Illustrative Development Plan

Area A

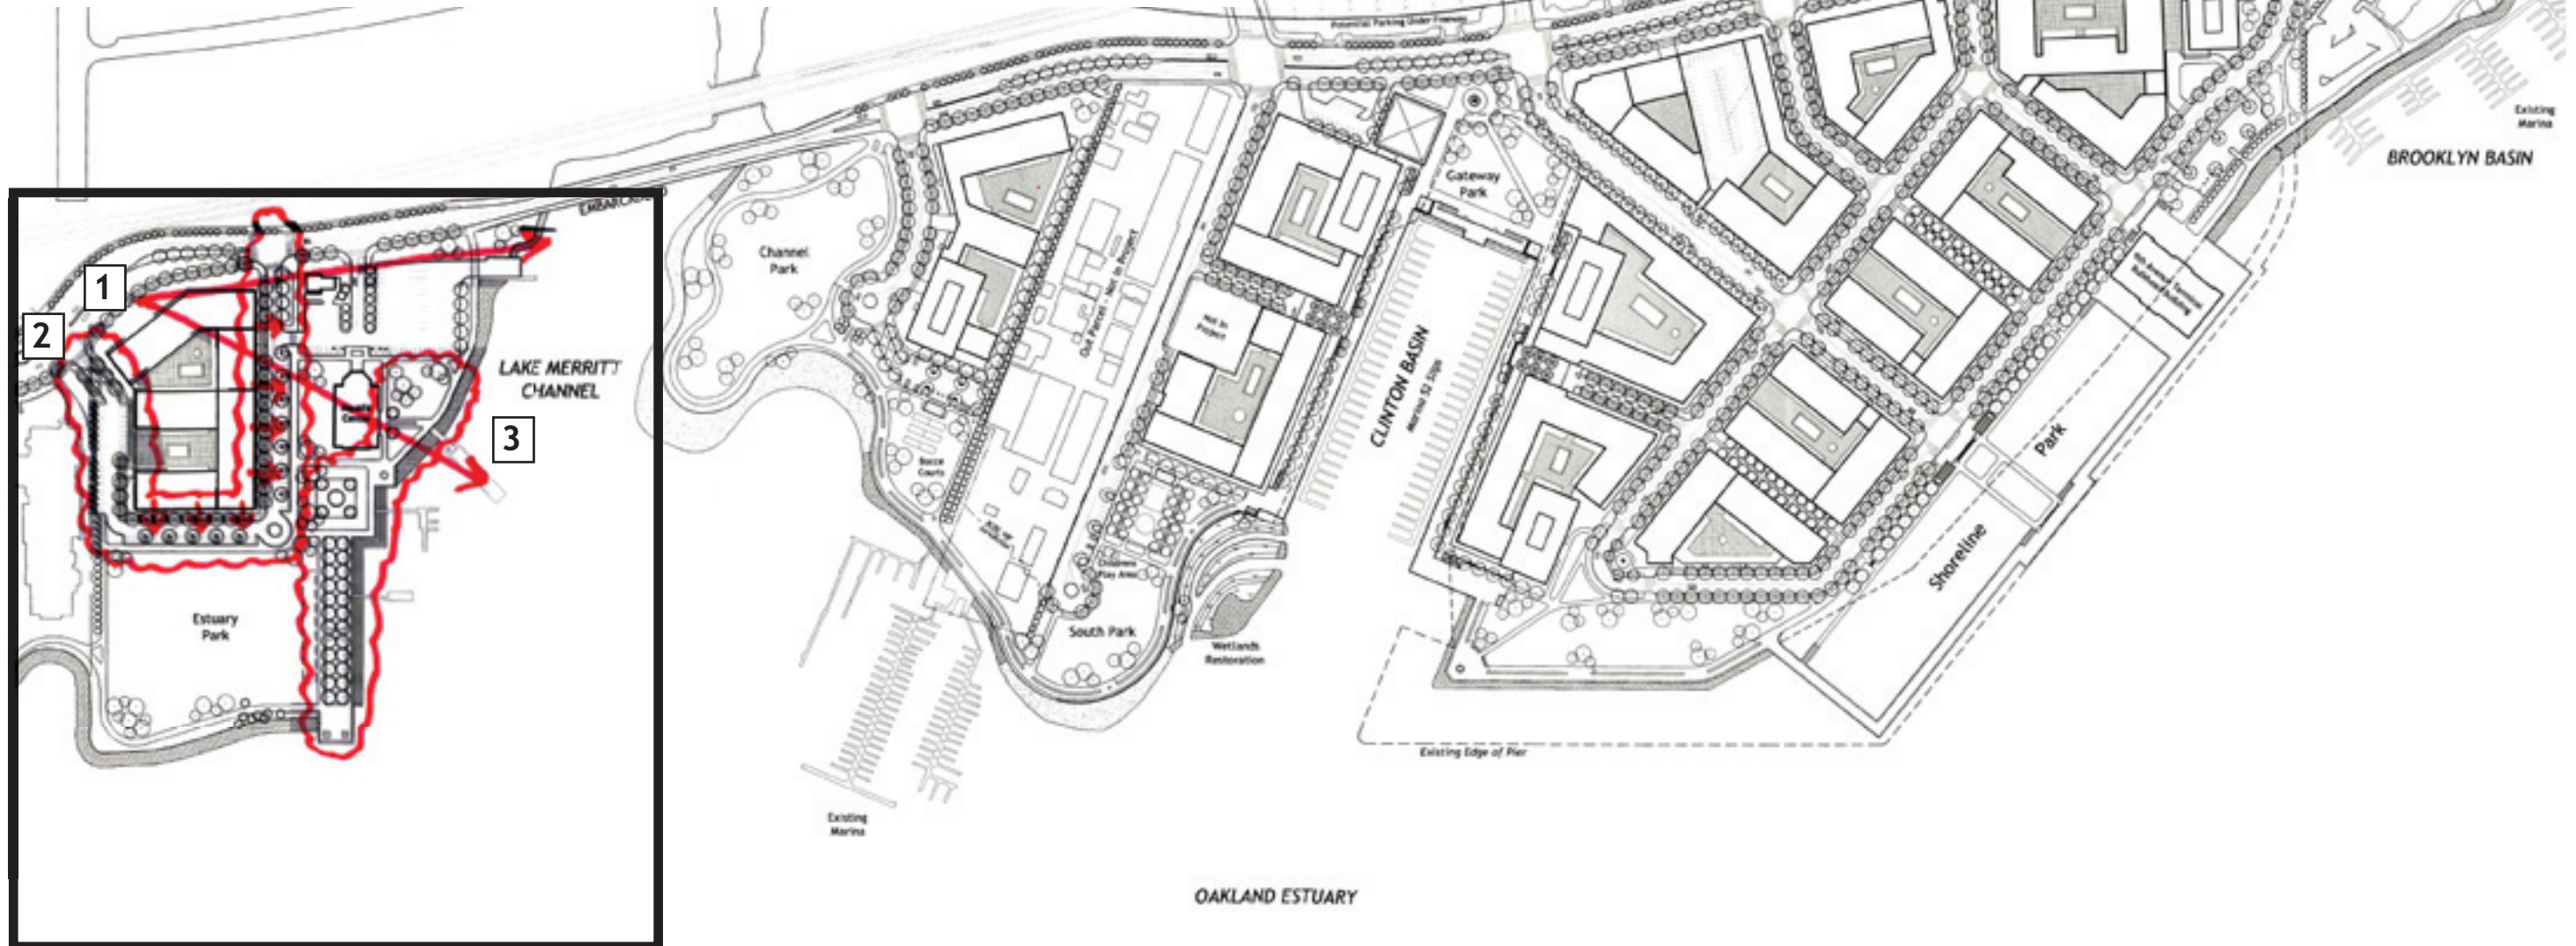
- 1- Increase visibility to waterfront and aquatic center from the Embarcadero
- 2- Provide streets rather than parking lots for access to the park
 - Locate Estuary Park parking to the west of housing
 - Integrate housing, street and park design with residential unit entries off streets facing the park
- 3- Need waterfront design that provides adequate programmed areas for future kayak/ canoe vendor needs, visitor drop-off and aquatic center uses

- Not privatize estuary park
- Consider reducing housing land coverage to accommodate the above

Area B

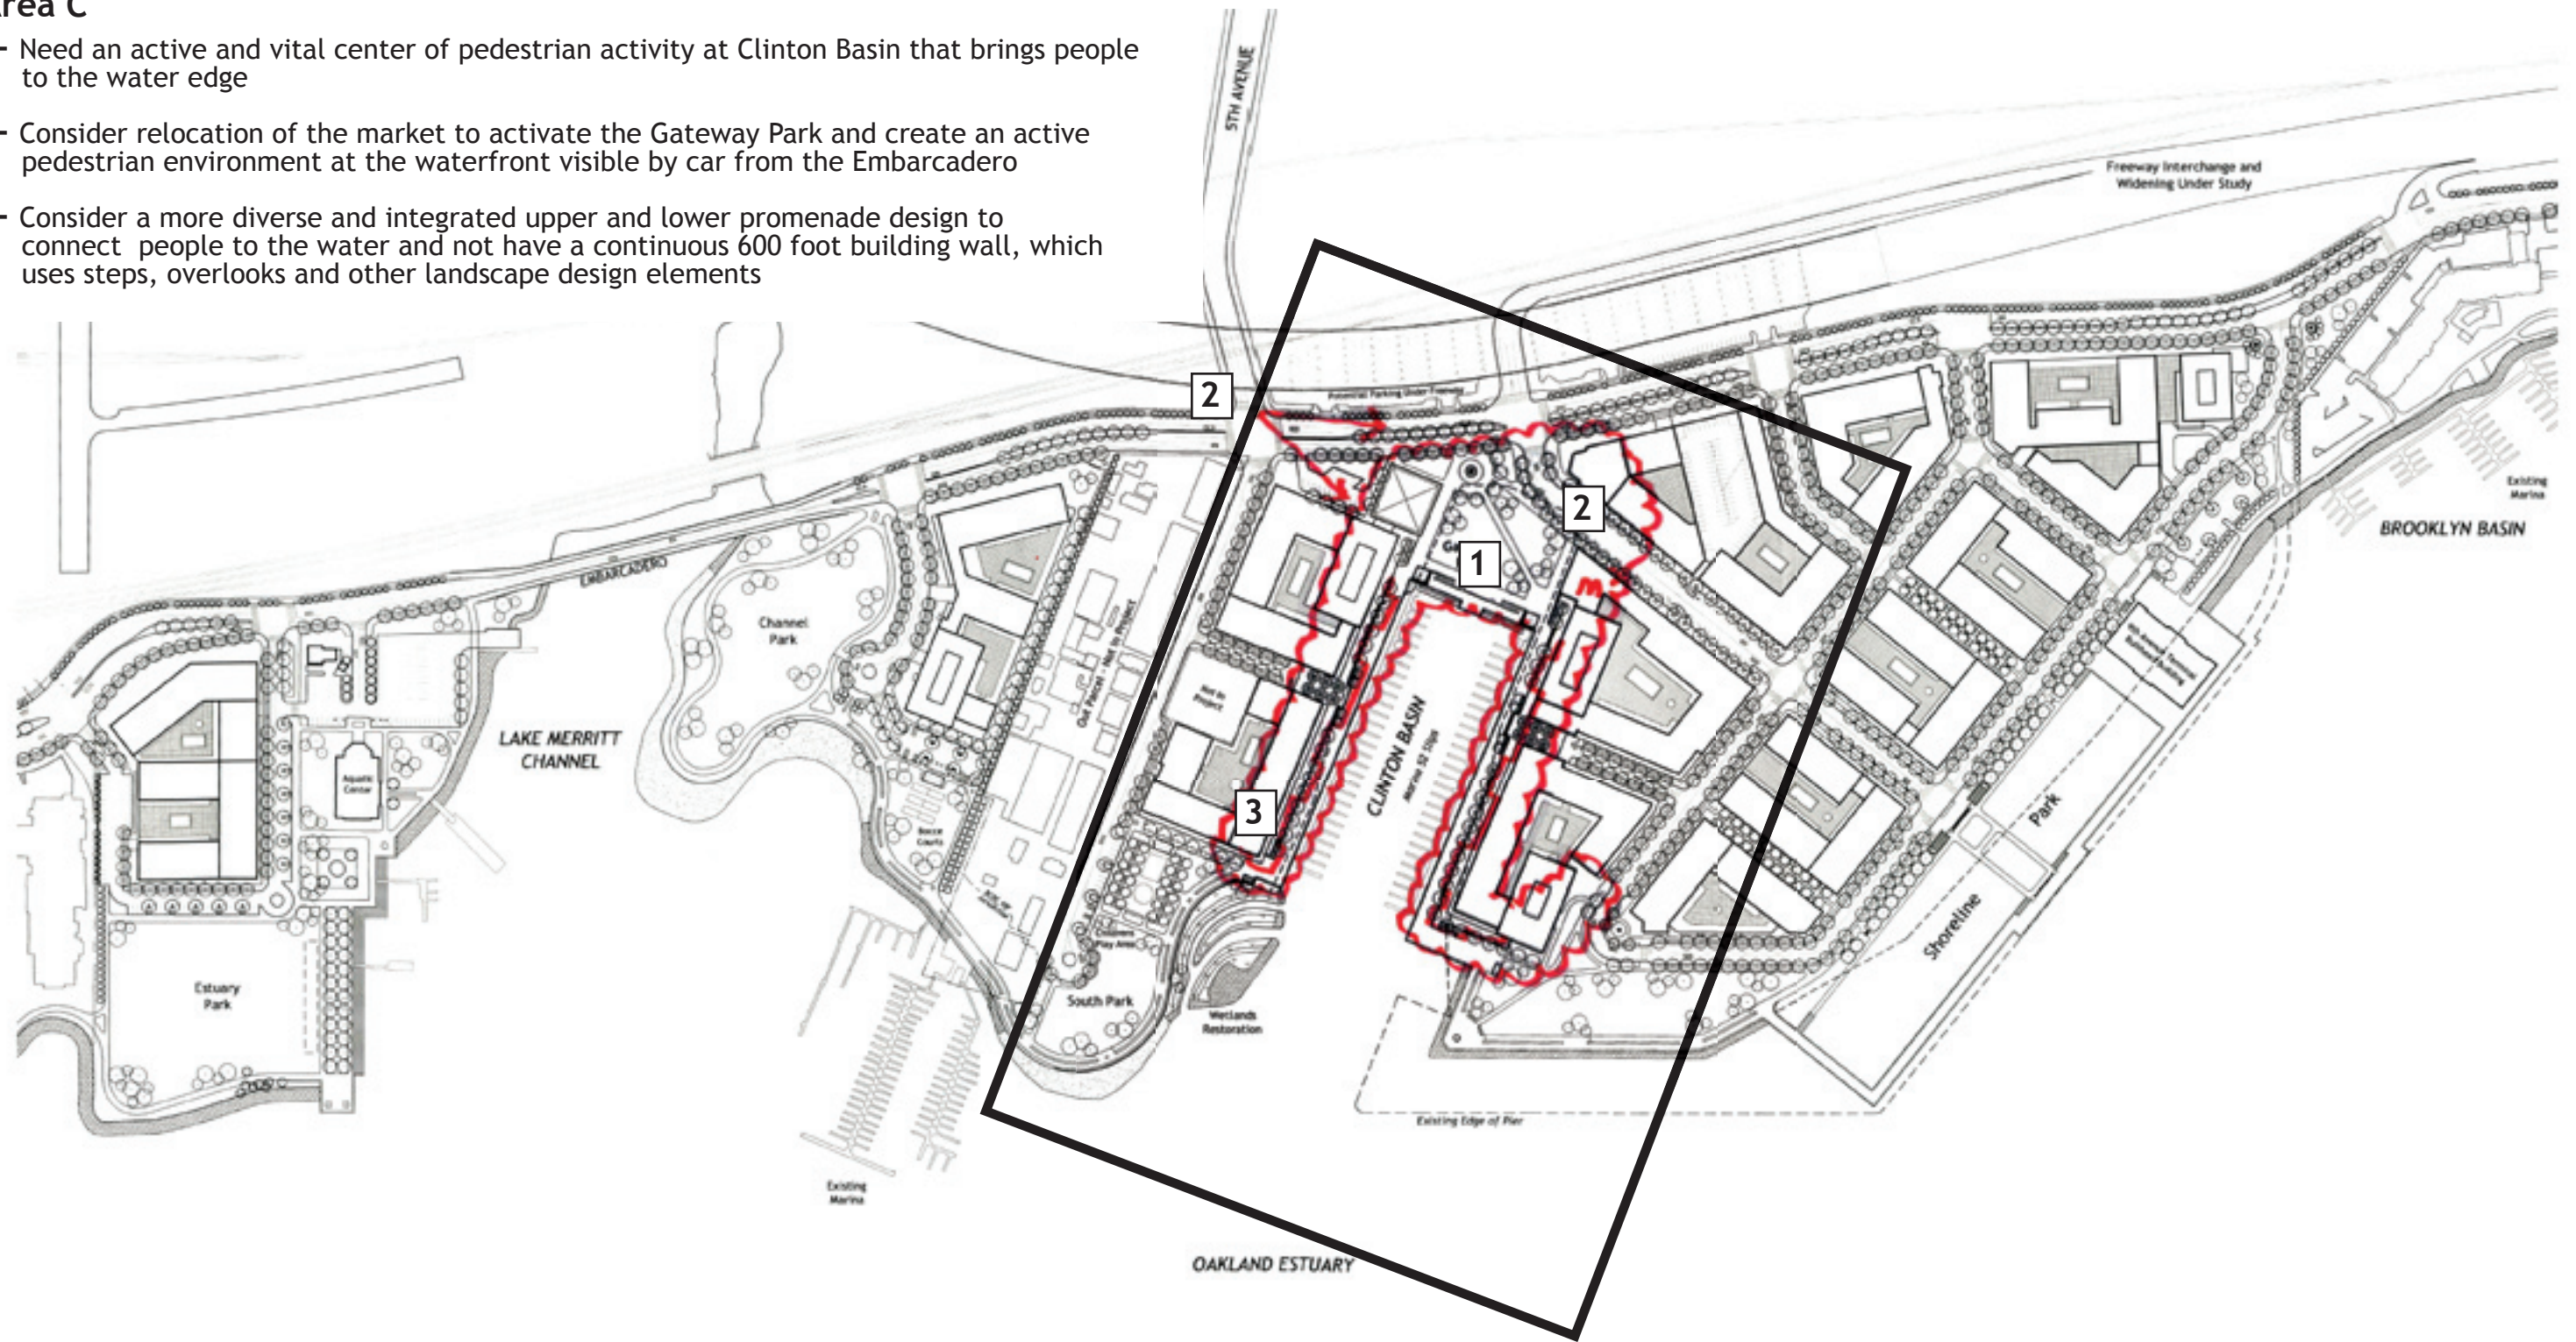
- 1- Need to redesign corner of Parcel K at the Fifth Avenue intersection to create a better entry to the community rather than a building corner; consider architectural design features, removing parking and landscape features that can draw people's attention to the Gateway Park, Clinton Basin and South Park
- 2- Need urban design options on how the residential buildings back onto and not tower over the artists community
 - Need more "park-ish" design for the Bay Trail along the western edge of the artists community
 - Consider ground floor residential facing the Bay Trail

- Consider opportunities for future connections through the artist's community to link Channel Park and Clinton Basin development areas together with city access if artist community redevelops
- Establish a height to building setback relationship to appropriately scale and orient residential buildings adjacent to low-scale artist's buildings
- Consider other park uses than bocce ball

- 3- Ensure opportunity for bicycle / pedestrian trail connection from Lake Merritt channel (to be completed by others) to Bay Trail

- 4- Consider a floating bridge for the continuation of the Bay Trail

Area C

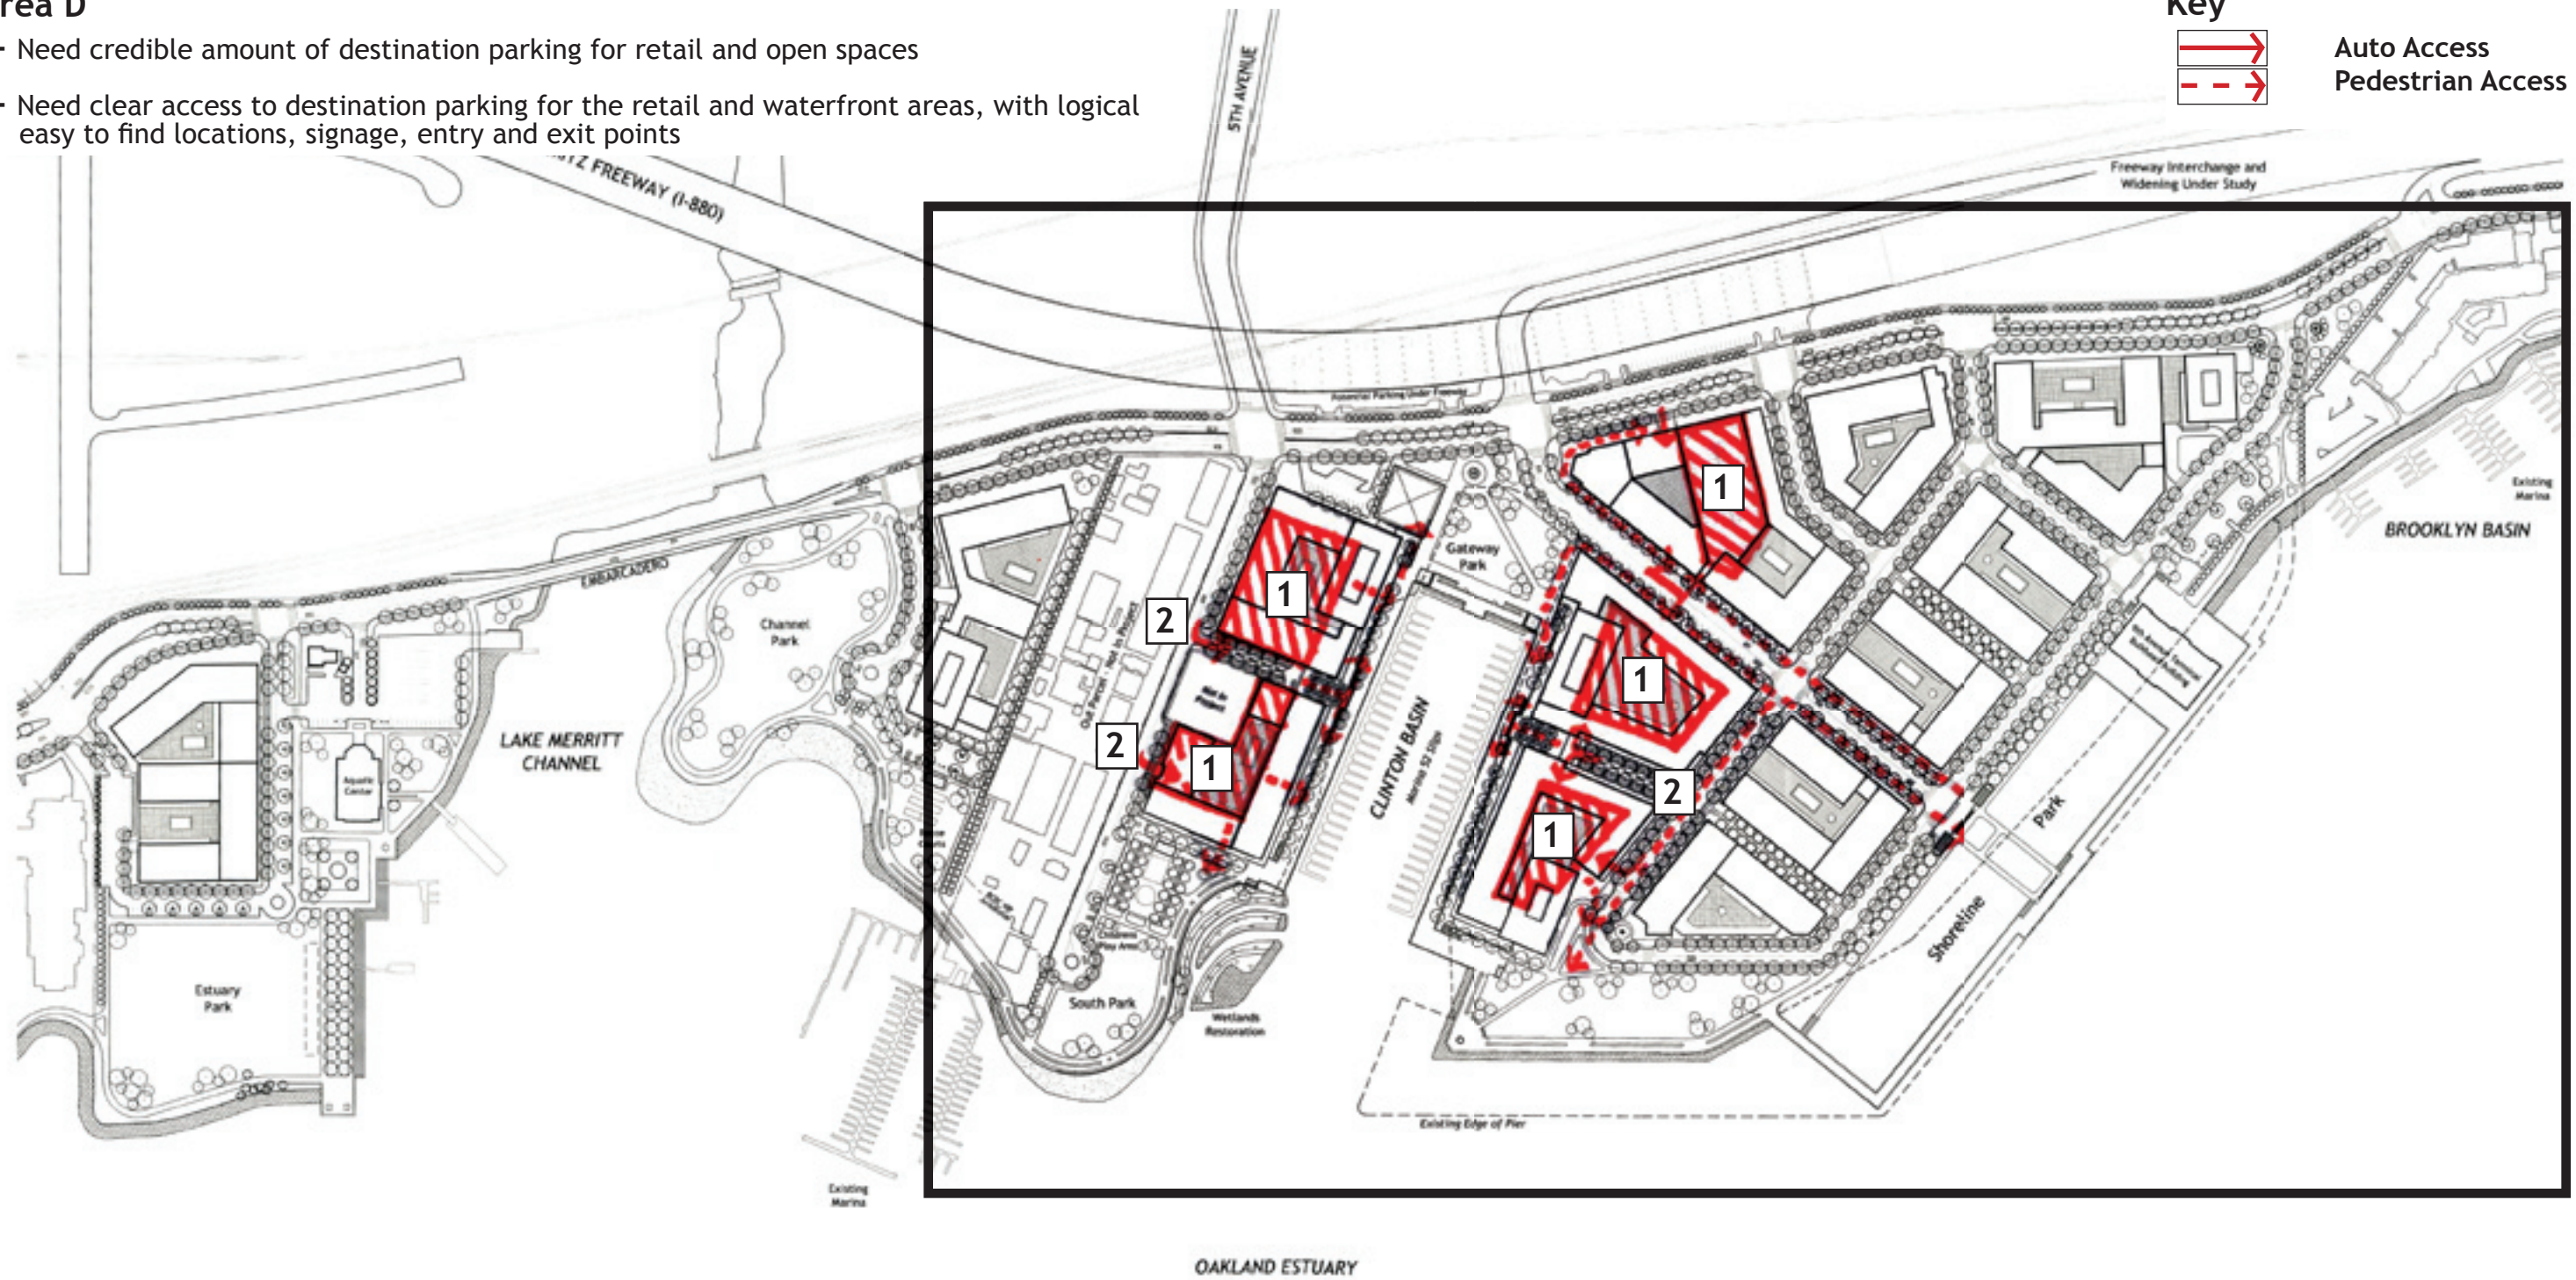
- 1- Need an active and vital center of pedestrian activity at Clinton Basin that brings people to the water edge
- 2- Consider relocation of the market to activate the Gateway Park and create an active pedestrian environment at the waterfront visible by car from the Embarcadero
- 3- Consider a more diverse and integrated upper and lower promenade design to connect people to the water and not have a continuous 600 foot building wall, which uses steps, overlooks and other landscape design elements

- 1- Need credible amount of destination parking for retail and open spaces
- 2- Need clear access to destination parking for the retail and waterfront areas, with logical easy to find locations, signage, entry and exit points
